DIXON MEADOWS JSP14-46

Public hearing at the request of Pulte Homes for Planning Commission approval of the Preliminary Site Plan with Site Condominium , Phasing Plan, Wetland Permit, Woodland Permit, and Stormwater Management Plan. The property is subject to a Planned Rezoning Overlay (PRO) Plan and Agreement. The subject property is currently zoned RA (Residential Acreage) with a Planned Rezoning Overlay associated with a Zoning Map Amendment, from RA (Residential Acreage) to RT (Two-Family Residential). The subject property is approximately 22.36-acre and is located on the east side of Dixon Road, north of Twelve Mile Road (Section 10) and the applicant is proposing a development of a 90-unit single-family residential detached site condominium.

PLAN REVIEW CENTER REPORT

Review Date: July 18, 2016
Review Type: Preliminary Site Plan
Project Name: JSP14-46 Dixon Meadows
Plan Date: June 27, 2016 (Incorrectly dated June 27, 2015)
Prepared by: Sri Komaragiri, Planner
Contact: **E-mail:** skomaragiri@cityofnovi.org; **Phone:** (248) 735-5607

SCALE: 1" = 150 FEET
DRAWN BY: C.R. / M.H.
CHECKED BY: J. K.W.
P.M.: J. ACKERMAN
JOB #: 14201056
FILE CODE: -
SHEET NO. 01

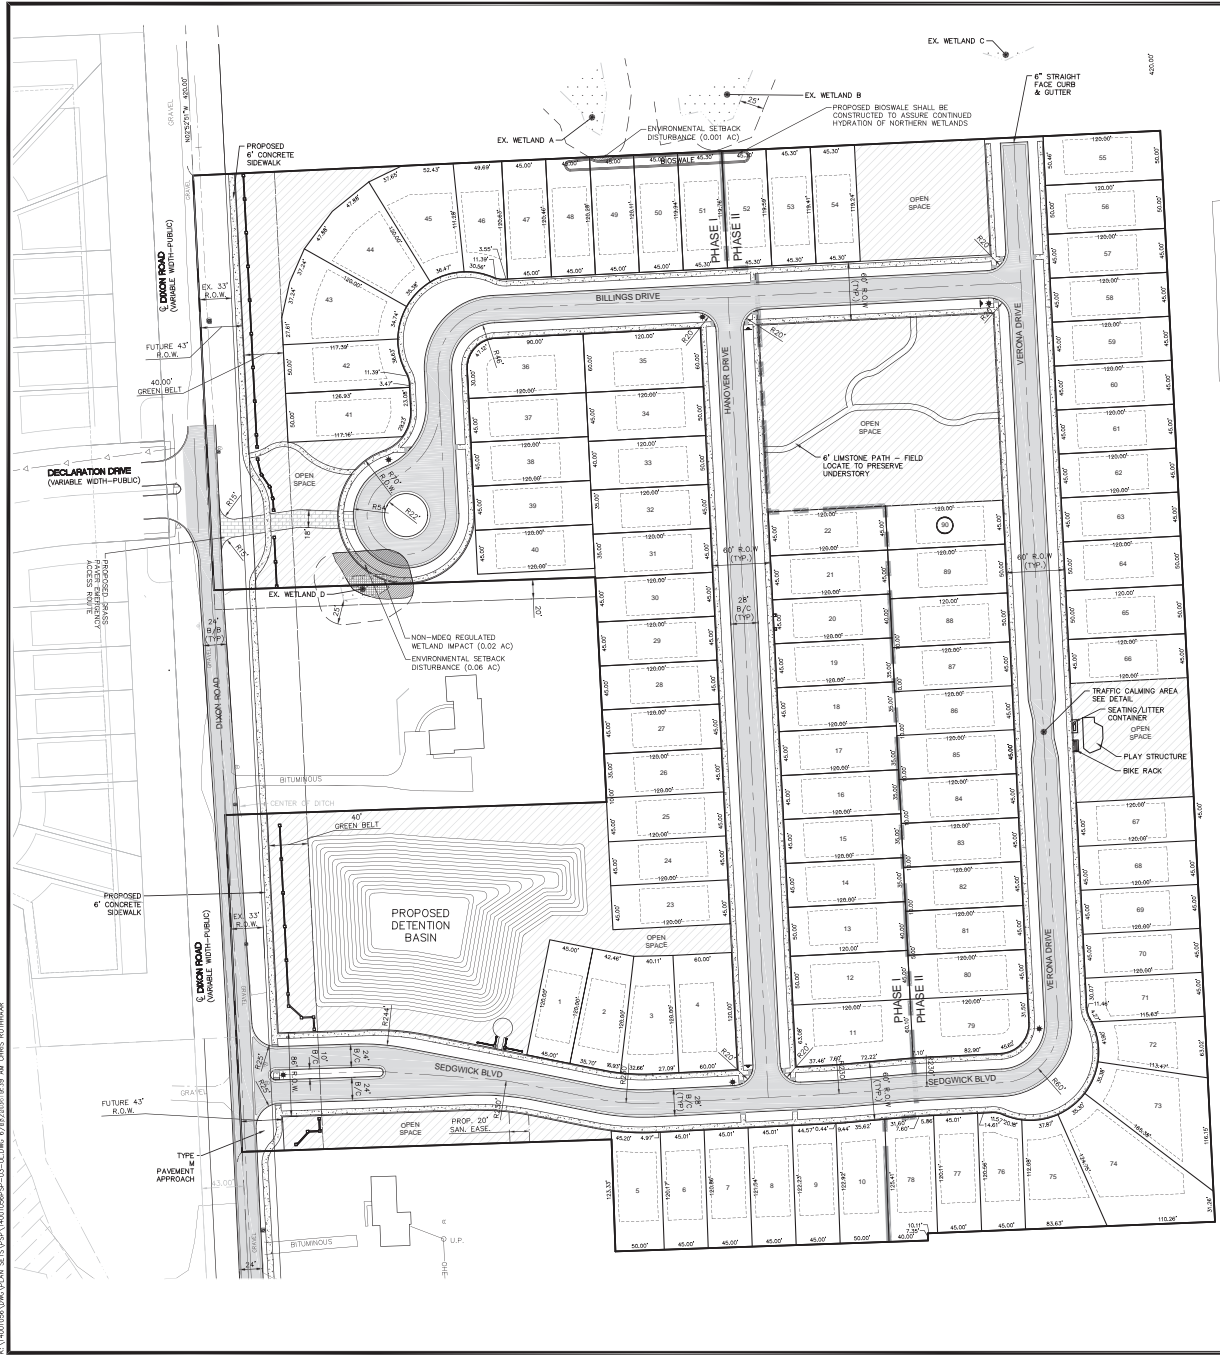
1. **Phasing:** Preliminary Site Plan indicates two phases. Phasing would require Planning Commission approval.
2. **Lot Width:** Lot widths for lots 73, 74, 75 and 43, 44, 45 are incorrectly labelled on the site plan. **Please refer to diagram on Page 2-15 of Zoning Ordinance for proper lot width measurement. *Lot width is the horizontal straight line distance between the side lot lines, measured between the two points where the front setback line intersects the side lot lines.*** The lot widths appear to be in conformance. **Provide the correct lot width to confirm that they all maintain a minimum of 45 feet width.**

4. **Lot Table:** **It is recommended to add columns to lot table on Sheet 03 to include respective lot widths and depth to width ratio for each lot.**

North Greenbelt

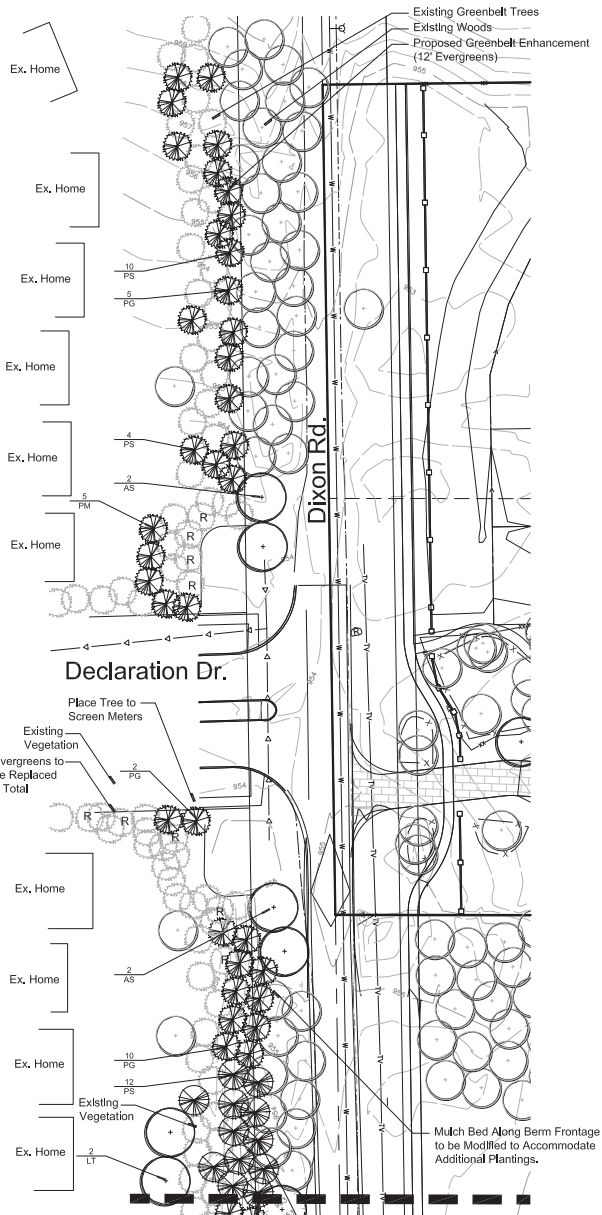
Note: Plant IDs needed for trees planted on Liberty Park greenbelt on Sheet L-1. Tree symbols are shown, and counts given on Sheet L-2 but ID labels are needed to aid in verification and installation.

- Plant labels are provided on sheets L-3 and L-9 for Dixon Road and the Liberty Park greenbelt respectively.
- Upsizing credits are not requested. The plan conforms to the Landscape Design Manual. The plan proposed 1.5 evergreens to count as 1 replacement tree.
